SUNDRY NOTICES AND REPORTS ON WELLS

8. Well Name and No. PAKSE 5 SOUTH FED COM/304H

APD CHANGE TO REVISE WELL NUMBER, FTP, LTP, BHL, CASING DESIGN

WELL LOCATION AND ACREAGE DEDICATION PLAT

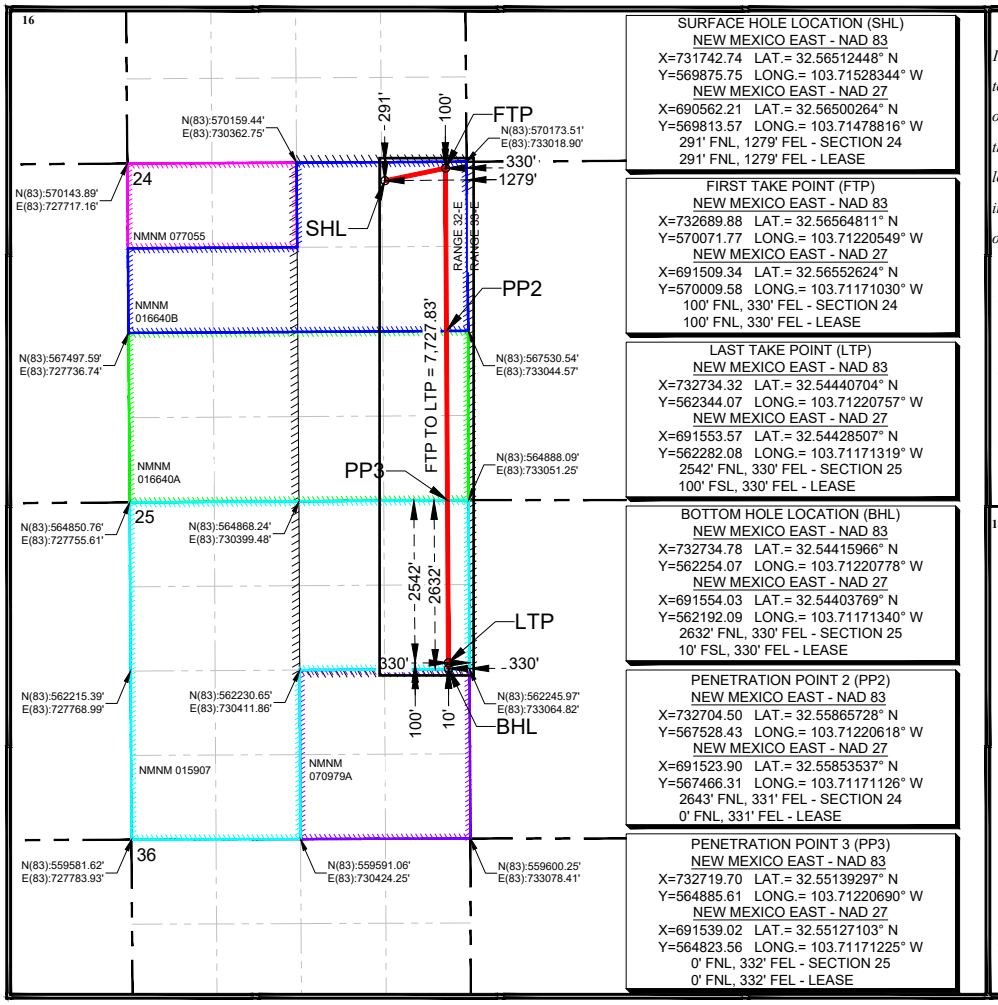
WELL NUMBER CHANGE
FROM: PAKSE 5 SOUTH FED COM 304H
TO: PAKSE 5 SOUTH FED COM 115H;
FIRST TAKE POINT
FROM: A-24-20S-32E; 100 FNL, 660 FEL
TO: A-24-20S-32E; 100 FNL, 330 FEL;
LAST TAKE POINT
FROM: H-25-20S-32E; 2541 FNL, 660 FEL
TO: H-25-20S-32E; 2542 FNL, 330 FEL;
BOTTOM HOLE LOCATION

FROM: H-25-20S-32E; 2631 FNL, 660 FEL

TO: H-25-20S-32E; 2632 FNL, 330 FEL;

WELL NUMBER, FTP, LTP, BHL

SURFACE HOLE LOCATION (SHL)
NEW MEXICO EAST - NAD 83
X=731742.74 LAT.= 32.56512448° N
Y=569875.75 LONG.= 103.71528344° W
NEW MEXICO EAST - NAD 27
X=690562.21 LAT.= 32.56500264° N
Y=569813.57 LONG.= 103.71478816° W
291' FNL, 1279' FEL - SECTION 24
291' FNL, 1279' FEL - LEASE

FIRST TAKE POINT (FTP)
NEW MEXICO EAST - NAD 83
X=732689.88 LAT.= 32.56564811° N
Y=570071.77 LONG.= 103.71220549° W
NEW MEXICO EAST - NAD 27
X=691509.34 LAT.= 32.56552624° N
Y=570009.58 LONG.= 103.71171030° W
100' FNL, 330' FEL - SECTION 24
100' FNL, 330' FEL - LEASE

LAST TAKE POINT (LTP)
NEW MEXICO EAST - NAD 83
X=732734.32 LAT.= 32.54440704° N
Y=562344.07 LONG.= 103.71220757° W
NEW MEXICO EAST - NAD 27
X=691553.57 LAT.= 32.54428507° N
Y=562282.08 LONG.= 103.71171319° W
2542' FNL, 330' FEL - SECTION 25
100' FSL, 330' FEL - LEASE

BOTTOM HOLE LOCATION (BHL)
NEW MEXICO EAST - NAD 83
X=732734.78 LAT.= 32.54415966° N
Y=562254.07 LONG.= 103.71220778° W
NEW MEXICO EAST - NAD 27
X=691554.03 LAT.= 32.54403769° N
Y=562192.09 LONG.= 103.71171340° W
2632' FNL, 330' FEL - SECTION 25
10' FSL, 330' FEL - LEASE
